BRANCHWOOD SUBDIVISION, RESUBDIVISION OF LOT 3

BRANCHWOOD SUBDIVISION, RESUBDIVISION OF LOT 3

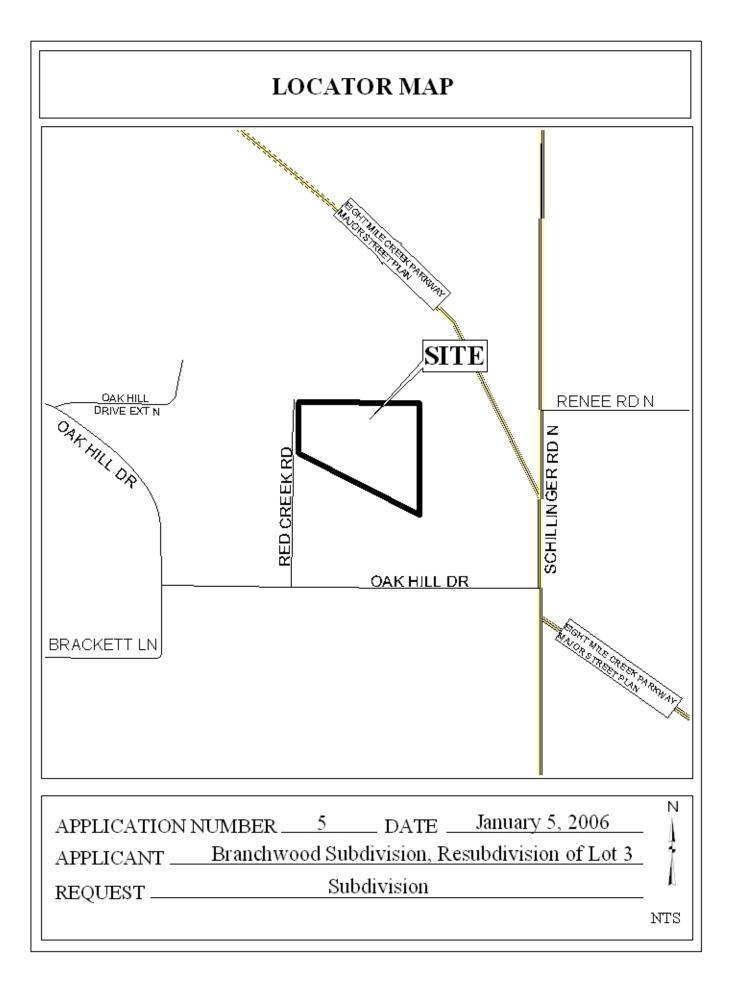
As indicated on the Vicinity Map, ponds are located on the site and as such the area may be environmentally sensitive; therefore, the approval of all applicable federal, state and local agencies would be required prior to the issuance of any permits.

Additionally, as indicated on the plat, Red Creek Road is a gravel road that is substandard. As a matter of policy, the Planning Commission typically does not approve subdivision on gravel roads that increase the number of lots accessing the gravel road.

This site is located in the County, thus a note should be placed on the final plat stating that any lots which are developed commercially and adjoin residentially developed property must provide a buffer, in compliance with Section V.A.7. of the Subdivision Regulations.

The 25-foot minimum building setback lines are not shown, but would be required on the final plat.

Based on the preceding, this application is recommended for denial for the following reason: 1) the application would increase the number of lots on a substandard (gravel) road.
